SUNDRY NOTICES AND REPORTS ON WELLS

7. Farm or Lease Name: WEST ORPHA UNIT

8. Well No.: 33-73 14-1H

Please see the revised footages:

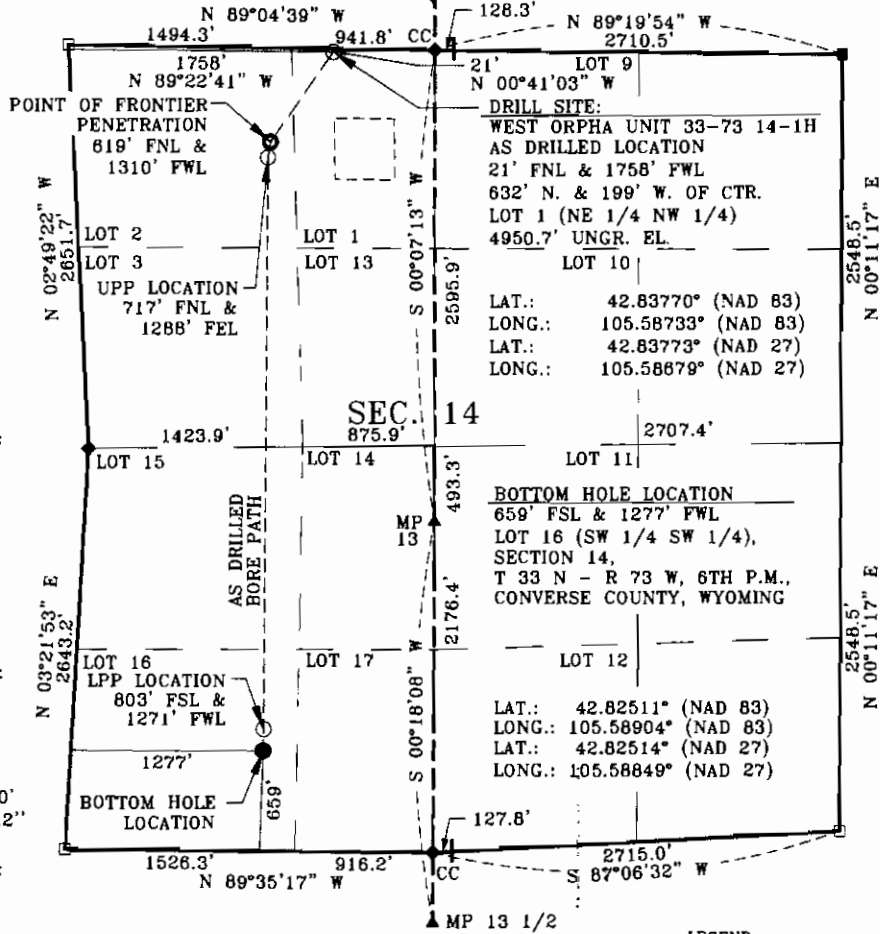
SHL: 21 FNL & 1758' FWL NENW LOT 1 Section 14-33N-73W
42.83770; -105.58733

BHL: 659' FSL & 1277' FWL SWSW LOT 16 Section 14-33N-73W
42.82511; -105.58904
